I travel regularly around Glossop and Simmondley by foot and by bike and also by car (but as little as I can by car).

On the maps I am showing with the green arrows crossings that are already dangerous for pedestrians to navigate accross for example accross Turnlee Road/Primrose Lane which is in Simmondley. This is a very important road as it splits up Simmondley and Glossop and you can't get round it any other way, its really long to mainstream roads either end. Cars and trucks already use this road a lot and cars seem to have no idea of the speed limit. Also the crossing points even the best ones in green have blind corners and are pretty dangerous. O often run accross with my little boy to be sure we don't get a car coming on us by surprise. I have asked the council and MP before to make a crossing for pedestrians here or add speed bumps to no avail. Even the staff at transport Derbyshire admitted there was nothing they could do as there was no budgets and one lady agreed with me this wasn't a good situation and as someone who printed sustainable travel she agreed.

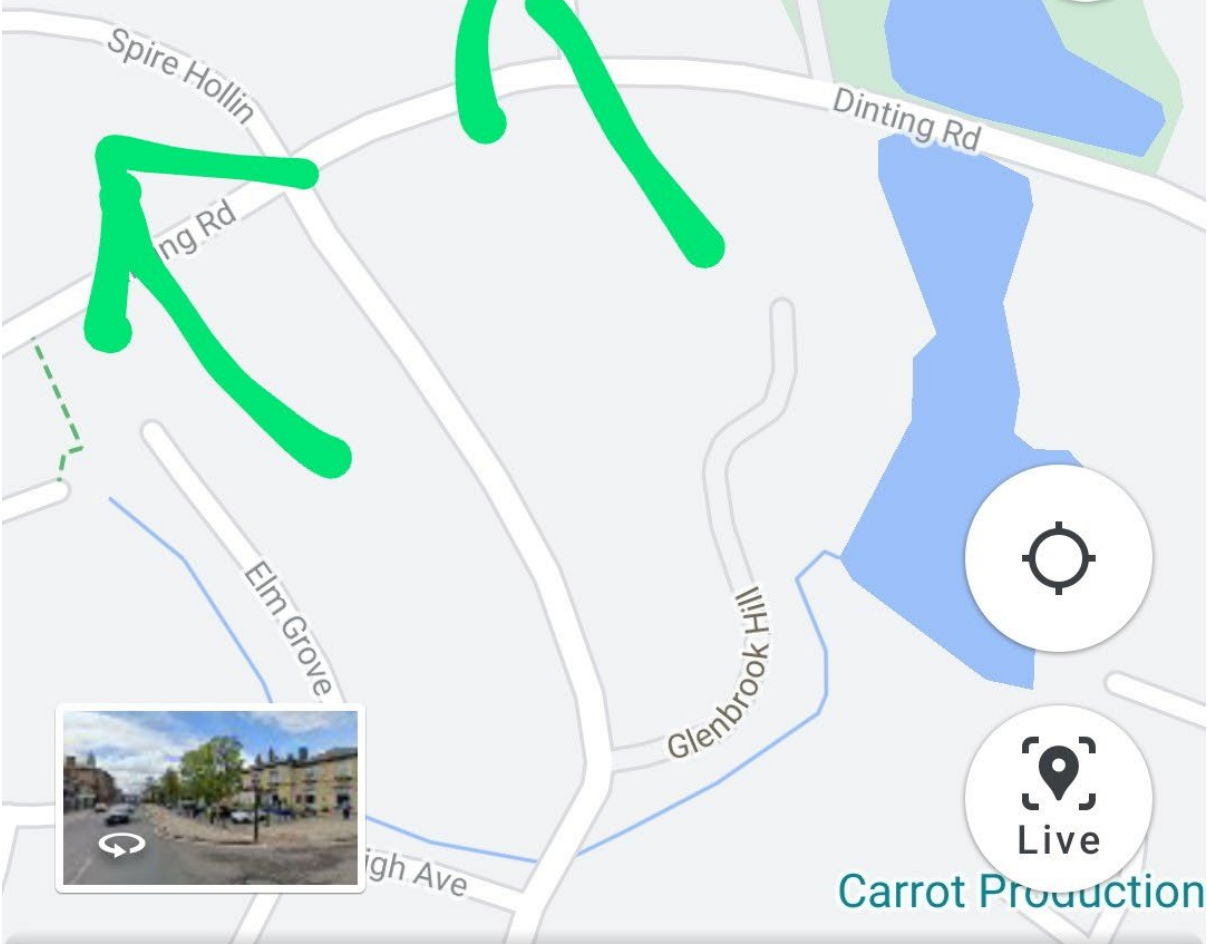
The other road I show on the two remaining maps is Dinting Road at two different points along it. This road is also a key road with very fast cars. I try to show on one map in green arrow how people would try and cross this road to get the swimming pool and also on the 2nd map to the Glossopdale School. Both of these crossings of the road are currently already dangerous and there is no way round it.

Near the school green arrow I have shown there is a crossing but as it doesn't have lights pr anything its just some markings it causes pedestrians and cars to make indecisive gestures for kids to cross or say they should cross and vice versa and then the kids don't look the other way if a car gestures its okay you can go. It's an accident waiting to happen already and potentially one that will involve some kids from that school. I'm really sad to hear that the new road proposals could increase traffic on Dinting Road, this is a real back track for the area on sustainable travel promotion and I think this will cause accidents.
